# PRODUCT ADVISORY NOTICE

**SUBJECT: Temporary color change of 76HP, 90B and 90HB DIP actuators due to plastic material shortage**

Bulletin #1341

DIP Actuator Temporary Color Change Due to Material Shortage

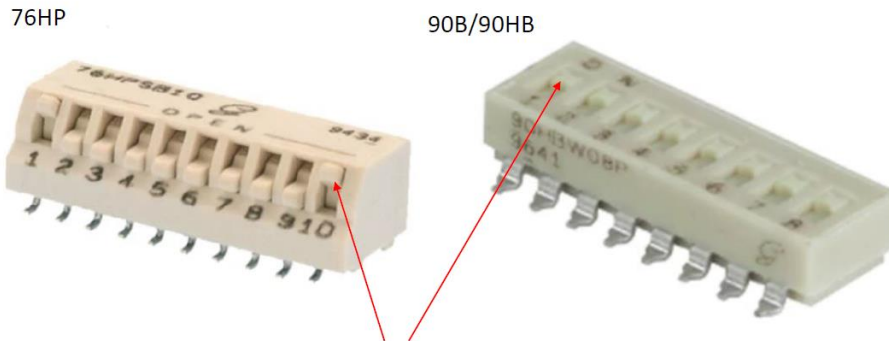
Due to a shortage of the natural colored plastic material used to mold the actuators of the affected DIP switches, the color will be temporarily changed to black to avoid production delays.

Color of DIP actuators (currently natural) will be temporarily changed to black to prevent production delays.

There is no change to the form, fit, or function of the products. The parts will be produced using the same plastic material, only in an alternative color (black).
